APPENDIX D

RESPONSES TO PUBLIC COMMENTS

RESPONSE TO COMMENTS MATRIX

Figure 1. Bedrock geologic map of LBNL. (modified from Figure 4.2-1 of PES and LBNL 2000)

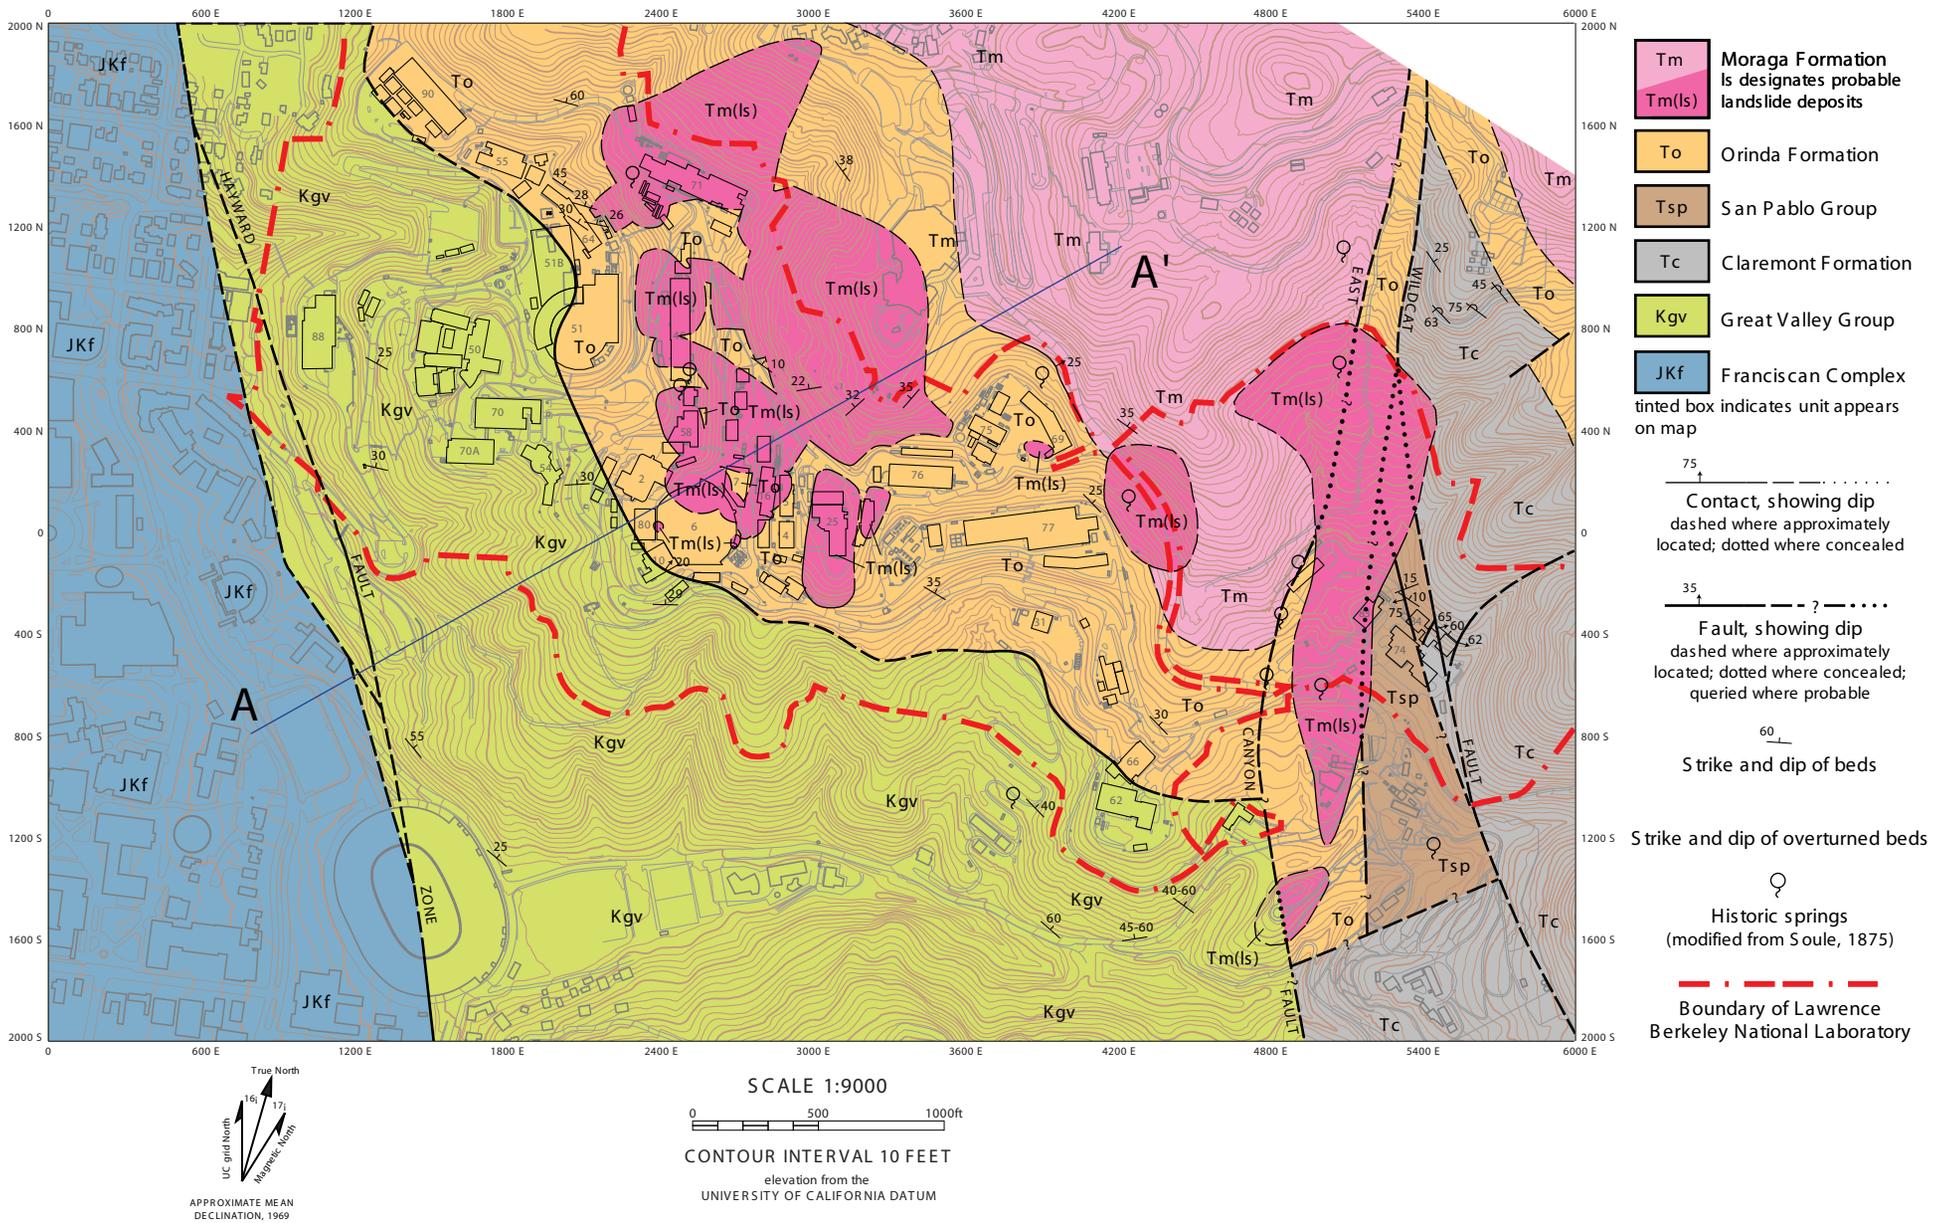
Many public comments on the Draft EA state or suggest that no more buildings should be constructed at Lawrence Berkeley National Laboratory (LBNL) due to the unstable geological conditions of the main hill site. Comments largely reiterate or mirror the hypotheses put forward by University of California Berkeley (UCB) Professor Emeritus Garniss Curtis in an article published in the Berkeley Daily Planet in the autumn of 2008. This master response has been developed to address comments from the public regarding the geology of the main hill site and to correct factual errors and misrepresentations presented in those public comments.

In his 2008 article, Professor Emeritus Curtis argued that LBNL is underlain by two geologic structures of concern: 1) a volcanic caldera containing material with low strength, and 2) west-dipping Cretaceous strata sub-parallel to the slope above Foothill student housing. He alleged that the latter feature could cause the slope to fail during a major earthquake on the Hayward Fault and destroy all the buildings from the western margin of the LBNL site to Doe Library on the UCB campus and beyond, a distance of over 1,000 feet west of Gayley Road. In January 2010, the organization Save Strawberry Canyon and one of its representatives sent a letter to UC LBNL, posted a video to the web featuring Professor Emeritus Curtis, and published a commentary in the Berkeley Daily Planet reiterating these concerns. The letter and video presented a geologic cross-section of the LBNL main hill campus, and the video also presented a geologic map of LBNL. These figures portrayed most of the LBNL site as underlain by volcanic rock filling a caldera, portray this caldera fill as hundreds of feet thick, and indicate this fill is in direct contact with Cretaceous strata to the west. Public comments on the Seismic Phase 2 project Draft EA make repeated reference to these submissions and to Professor Emeritus Curtis' hypotheses of 2008.

Figure 1 shows the most recent and comprehensive bedrock geology map of the entire LBNL site, which was prepared by Parsons Engineering Science, Inc. (PES) and UC LBNL. This mapping data was drawn from hundreds of borings as well as from trenches, outcrops, construction excavations, and road cuts (PES and UC LBNL 2000). This map indicates that, contrary to the assertions by some commenters, volcanic rocks do not underlie most of the LBNL site, but rather occur in various isolated to semi-isolated masses. Calculations from this map indicate that 46 acres of the 202-acre site, or 23 percent of the LBNL property, is underlain by volcanic rock, sedimentary rock intercalated with volcanic rock, and sedimentary rock including volcanoclastics. The majority of these 43 acres are currently not developed, and the LBNL 2006 Long Range Development Plan (LRDP) and EIR do not anticipate further development in these areas.
